APPLICATION FOR
URBAN DESIGN COMMISSION
REVIEW AND APPROVAL

PROJECT ADDRESS: 1862 Beld St, Madison WI

PROJECT: WINGRA & PARK

WINGRA & PARK (#782512) MADISON, WISCONSIN CONSTRUCTION DRAWINGS ROOFTOP JULY 2010

PHOTO SIM 1
- TAKEN FROM SOUTH PARK STREET
- GROUND ELEVATION: 873'

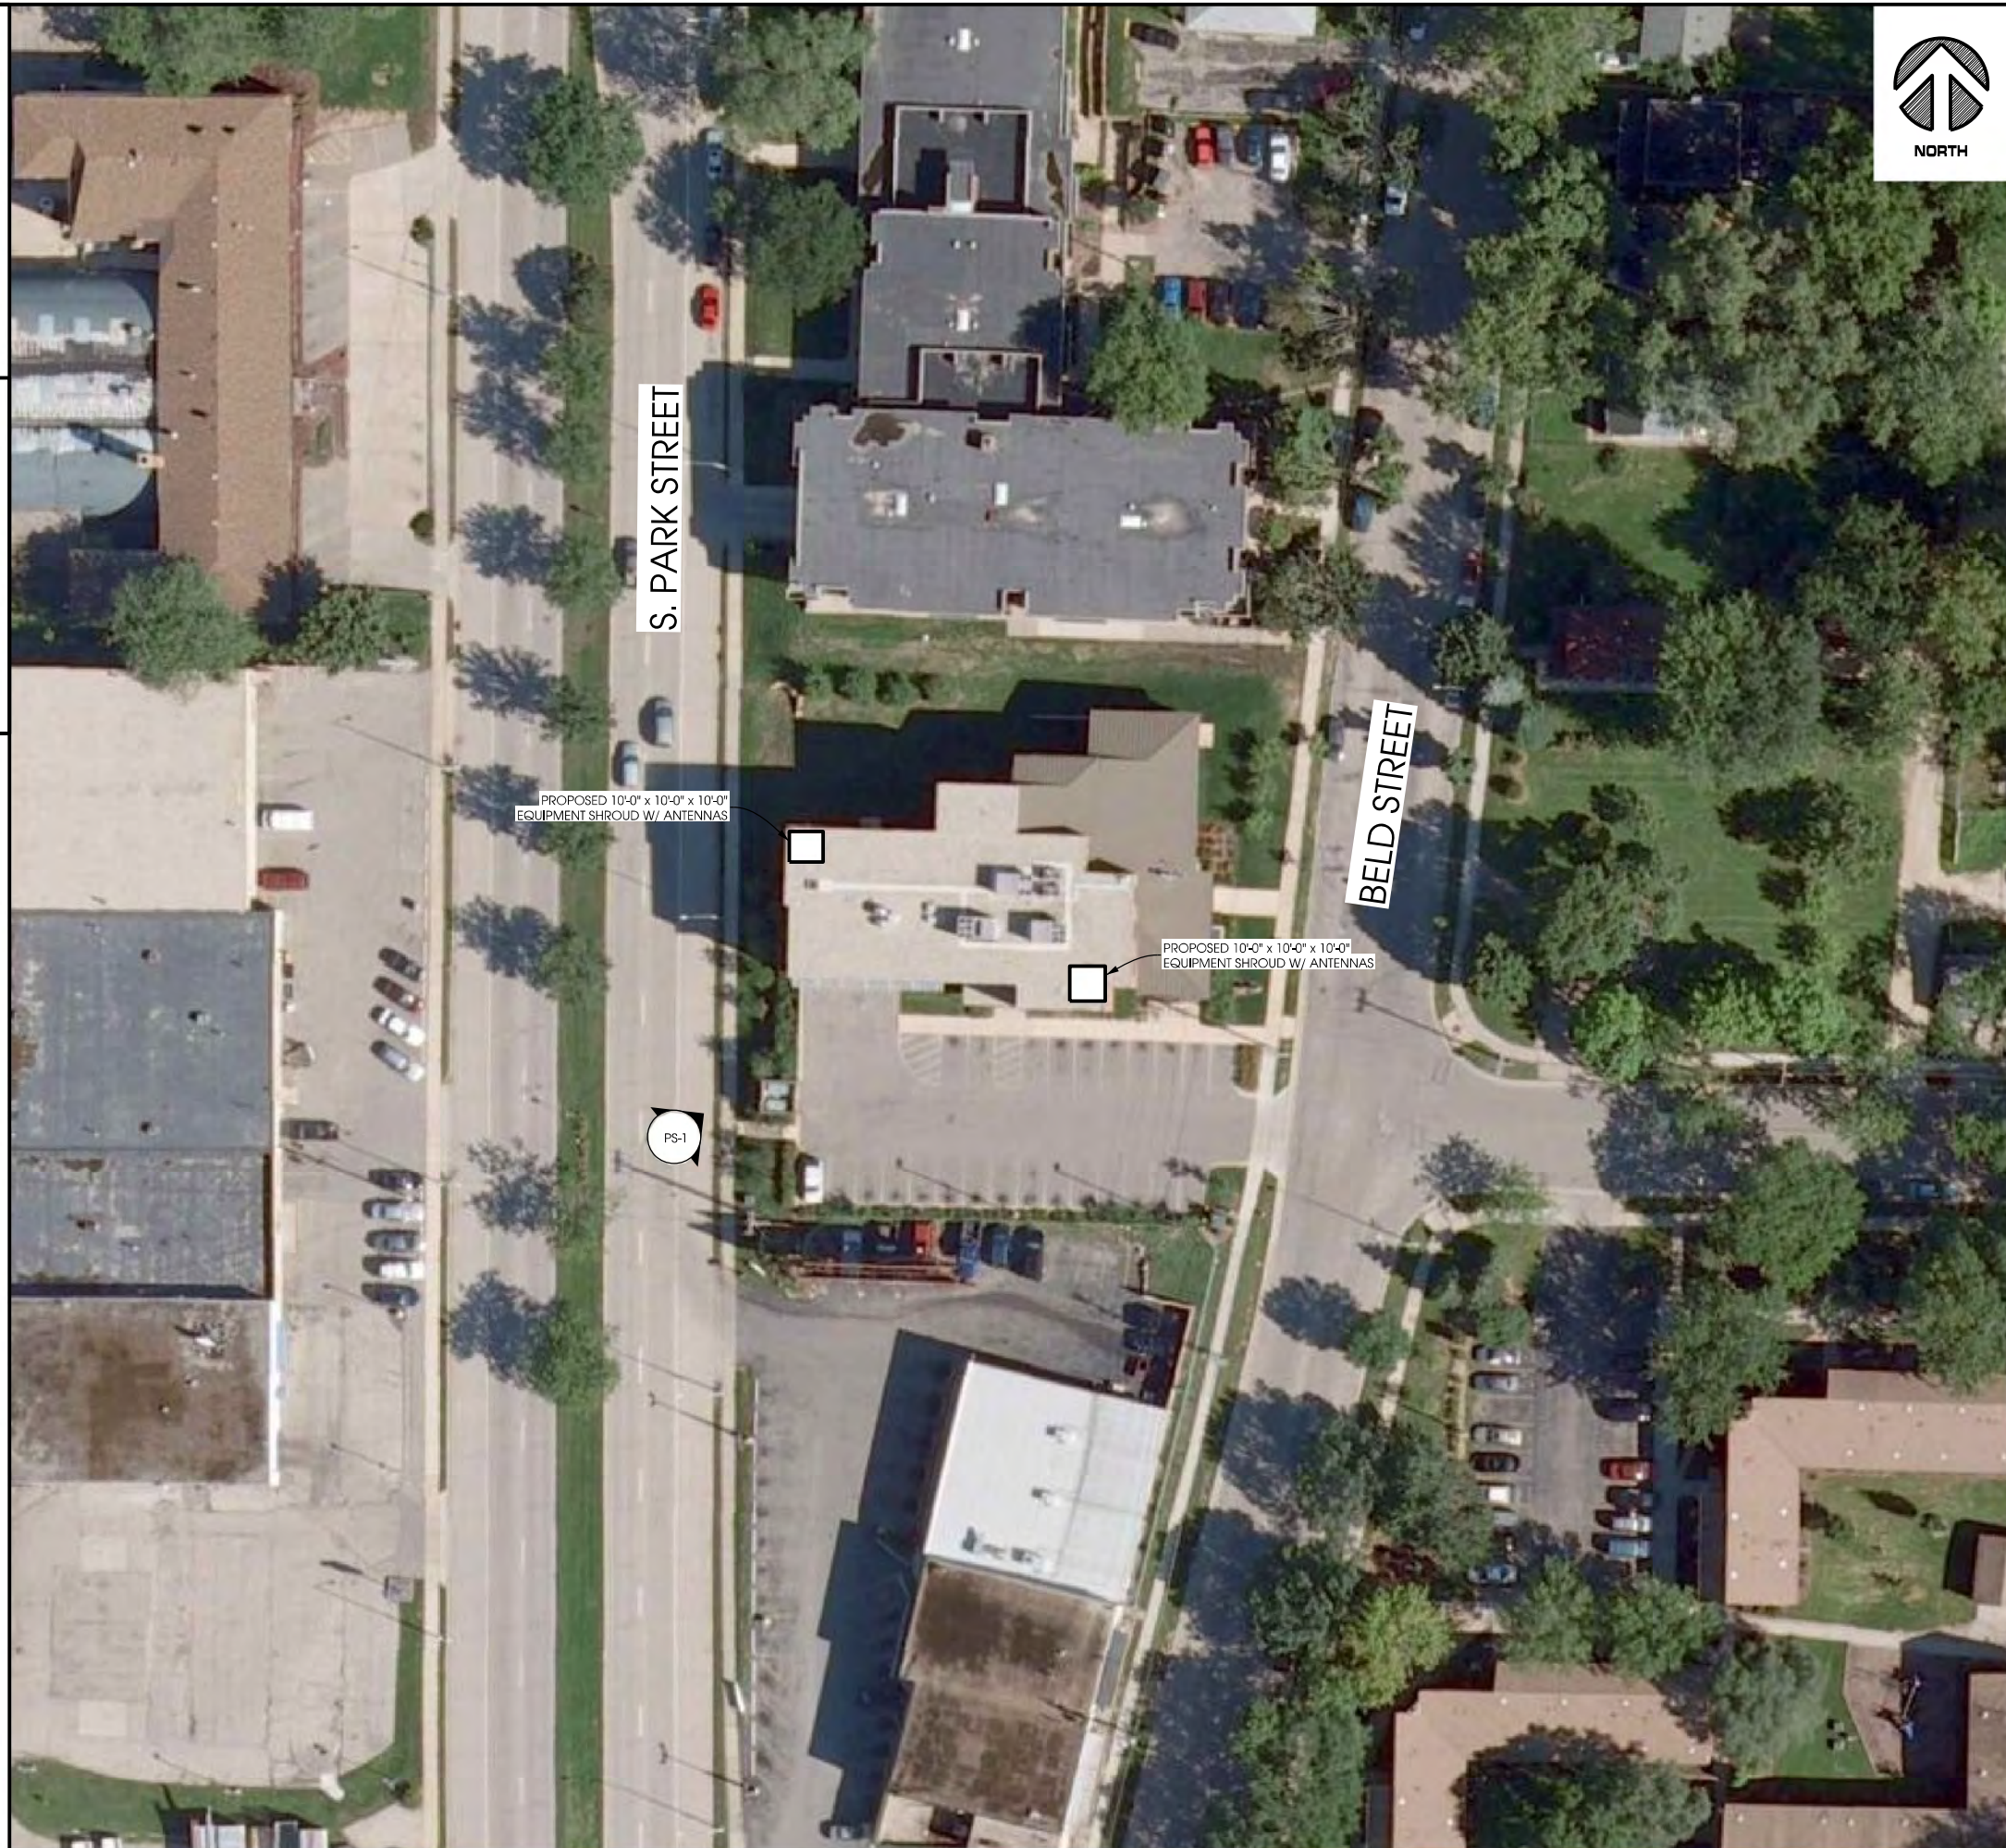
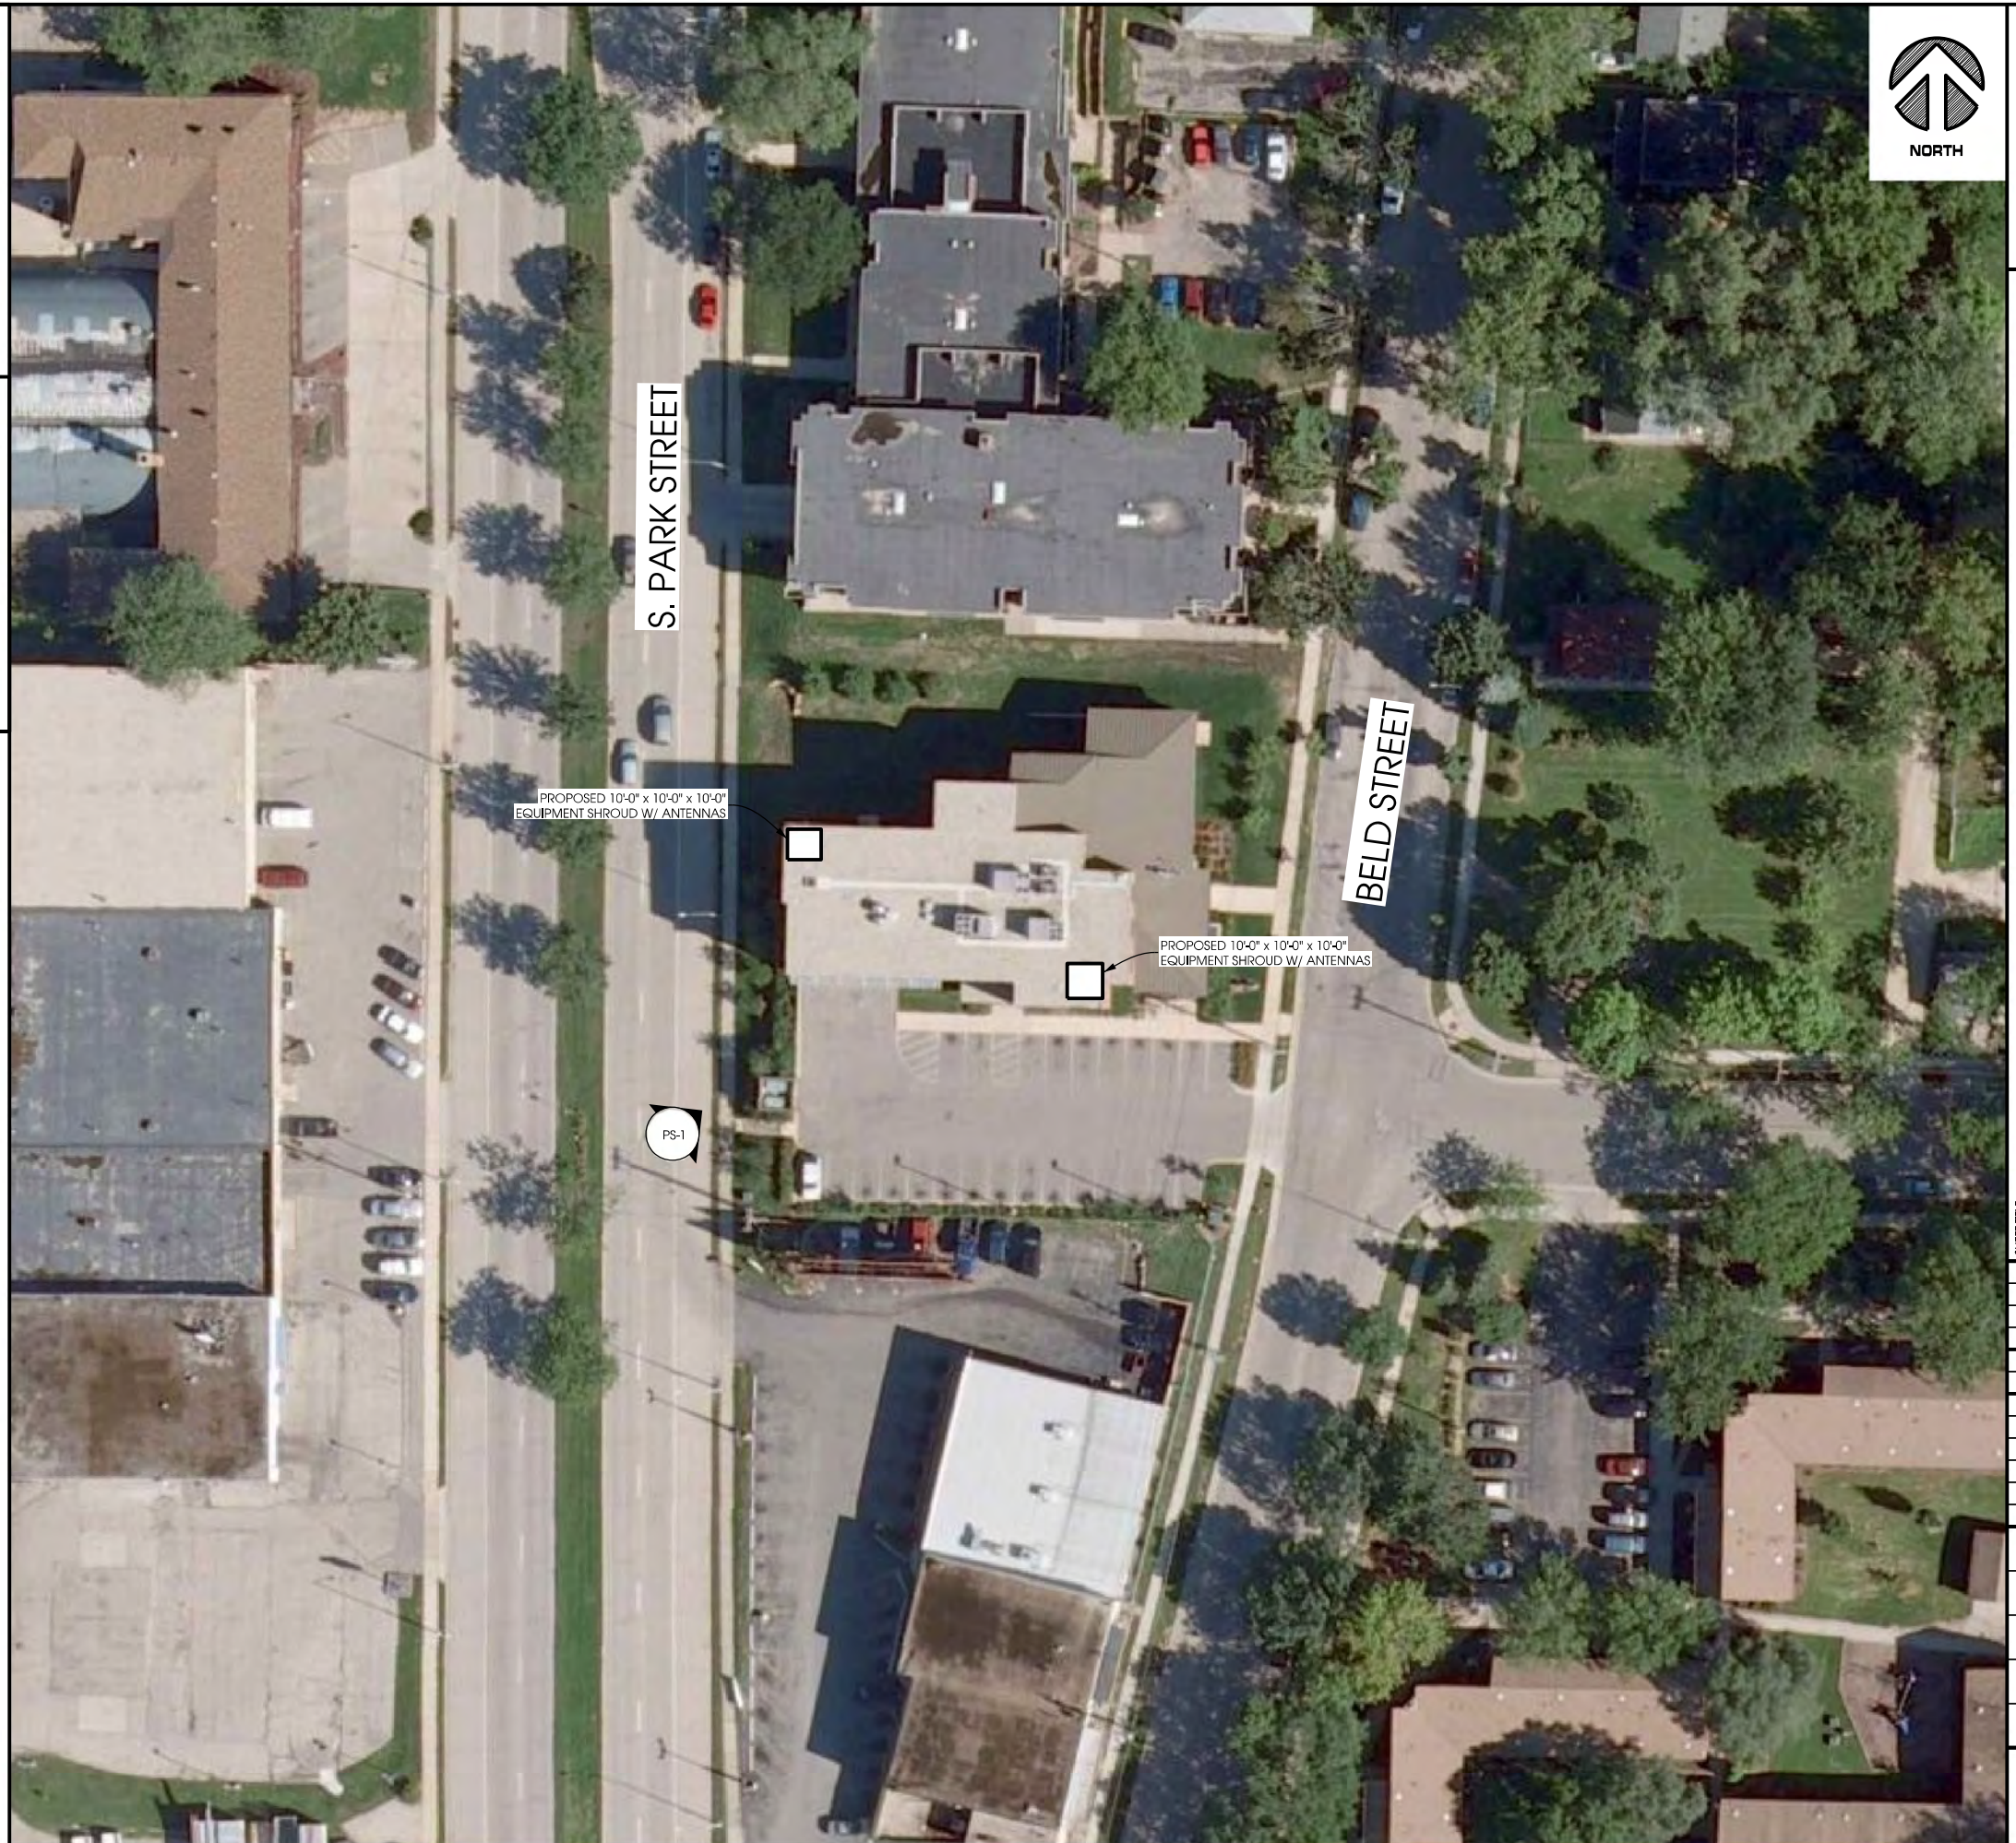
Antenna shroud - The antenna shroud has been revised to a louver type panel. The UDC requested contrasting architectural features, besides trying to match the brick. The louver design plays off the louvered sun shades above some of the windows along the front of the building. You'll notice in the photo sims we created we can either go with a silver color to match

A COAX ENCLOSURE
 A-5 SCALE: 11 X 17 - 1/2" = 1'-0"
 22 X 34 - 1" = 1'-0"

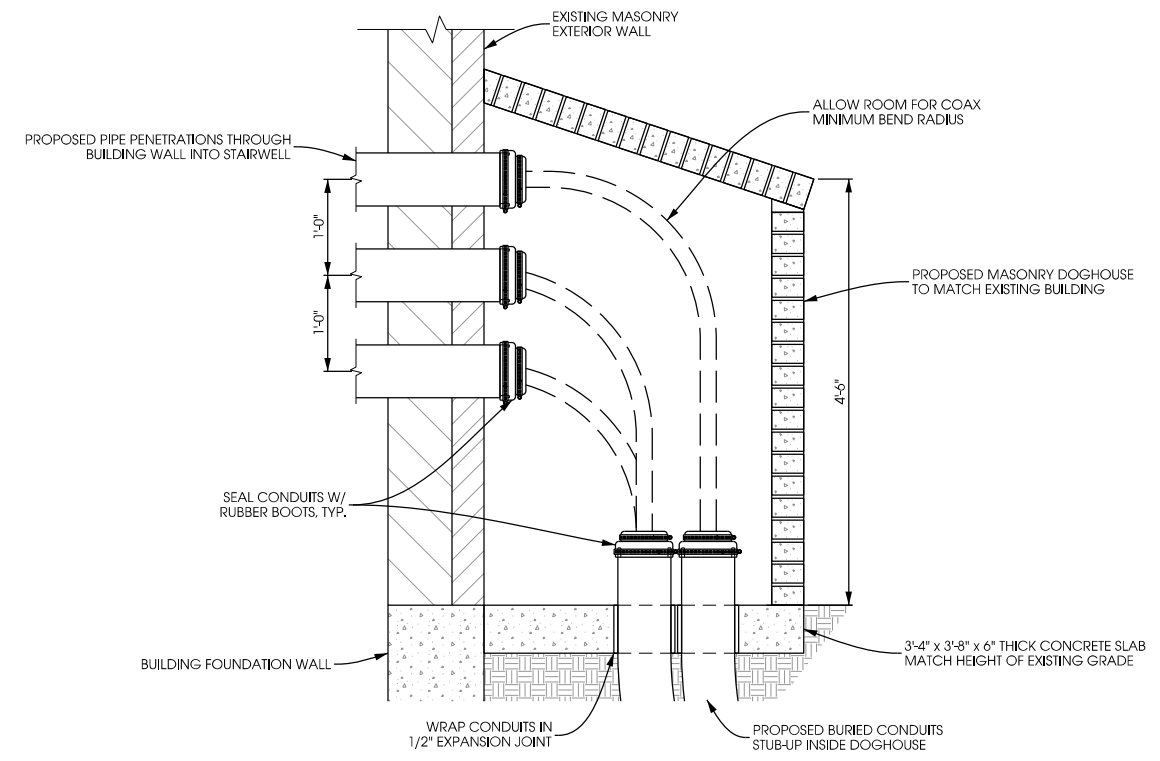
Coax routing - Instead of routing along the entire height of the building the revised design has a dog house along the exterior of the stair well. There will be a penetration in the stair well wall and rigid conduit routing the coax through the interior to a roof penetration behind one of the antenna shrouds. The Engineer revisited the site in hopes of finding alternative coax routing locations but all appear to be difficult to install.

NOTE:
 FINAL DOGHOUSE DESIGN TO BE VERIFIED W/ STRUCTURAL ANALYSIS
